Dublin Cycling Campaign
% Tailor's Hall,
Back Lane,
Dublin 8

14 January 2022

Submission on Dodder Greenway - Dodder Valley Park to Kilvere

Plan on Blue Haven Junction: Assessment using LTN 120 (UK Guidance)

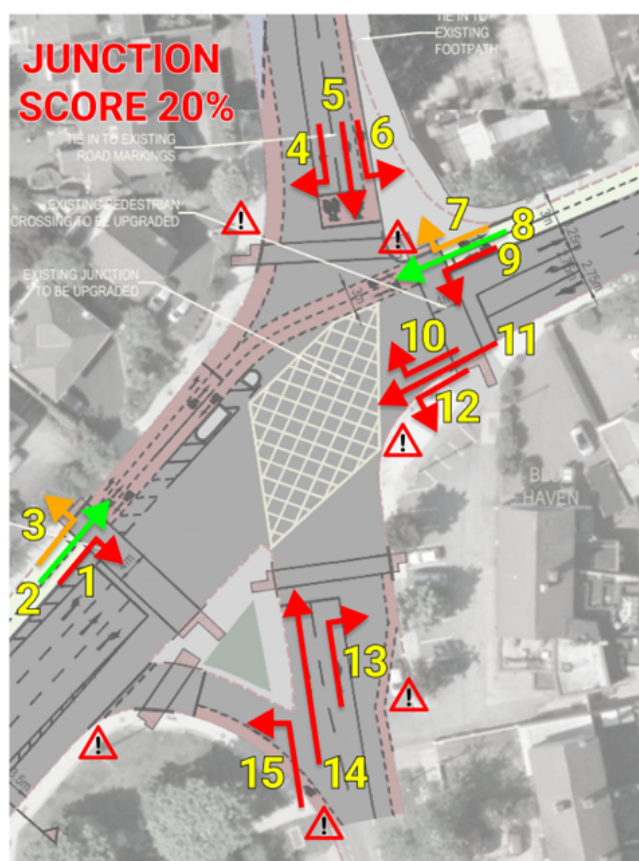
We assessed the preferred option using this tool and we believe this helps demonstrates how all cycle movements have not been adequately considered in the design. The junction score demonstrates a failure with a 20% score. We believe that, as presented at this early stage option, it would be a junction which is unsafe, uncomfortable to use and wouldn't afford adequate priority to sustainable modes of transport. We believe it is still too large and some crossing distances for walking and cycling are excessively long.

Expecting people cycling to dismount and use pedestrian crossings is unacceptable and amounts to the pedestrianisation of cycling. This type of provision does not deliver national or regional policy, the Development Plan commitments and is inconsistent with DMURS and the NCM. It will not achieve modal shift or help to meet climate

change targets. We do not believe this design adequately accounts for human behaviour. This is a major junction along the greenway and it should be safe, comfortable and afford people cycling adequate priority both on the greenway and from all approaches.

The following figure illustrates the various cycle movements assessed using the LTN 120 method, while the table summarises some of the criteria relevant to each score. Only straight ahead movements on the greenway itself appear to be up to standard and the overall junction score is 20%, which is a failure. Perhaps some movements could be argued to have an alternate score, however the junction would still not achieve the required score to demonstrate quality.
